Intersection ID: 18594	Main Street: WAKEFIELD_DR	Cross Street: SELWYN_AV	Location:	NW
ADA ID: B9B671B1DC20	Ramp Type: PerpDiag	Initial Pass/Fail: Fail	Overall Compliance: No	Severity Score: 42.5

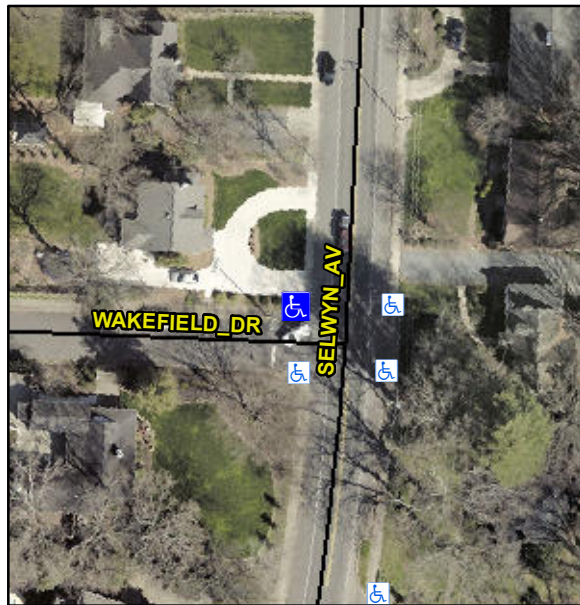
R304.5.1, R304.5.3

Compliance	Description	Data	Compliance	Description	Data
N/A	Ramp Length (in)	47.0	Yes	Ramp Slope (%)	7.9
No	Ramp Width (in)	32.0	No	Ramp XSlope (%)	8.7
N/A	Flare Type LT	N/A	N/A	Flare Type RT	N/A
N/A	Flare Slope LT (%)	N/A	N/A	Flare Slope RT (%)	N/A
N/A	Flare Traversable LT?	N/A	N/A	Flare Traversable RT?	N/A
N/A	Landing Length (in)	N/A	N/A	DWS Provided?	N/A
N/A	Landing Width (in)	N/A	N/A	DWS Contrast?	N/A
N/A	Landing Slope (%)	N/A	N/A	DWS Length (in)	N/A
N/A	Landing X Slope (%)	N/A	N/A	DWS Full Width?	N/A
N/A	Landing Curb? (Y/N)	N/A	N/A	DWS Offset (in)	N/A
N/A	Shared Landing?	N/A			
N/A	Gutter Ponding?	N/A	N/A	Gutter Slope (%)	N/A
N/A	Gutter Lip Ht (in)	N/A	N/A	Gutter X Slope (%)	N/A
N/A	Painted X Walk1?	No	N/A	Painted X Walk2?	No
	X Walk 1 Direction	To SW		X Walk 2 Direction	To E
N/A	X Walk 1 Width (in)	N/A	N/A	X Walk 2 Width (in)	N/A
	X Walk 1 Slope (%)	4.0		X Walk 2 Slope (%)	6.2
	X Walk 1 X Slope (%)	5.6		X Walk 2 X Slope (%)	0.5

Remove & Replace Curb Ramp With Two New Directional Ramps or Equivalent.
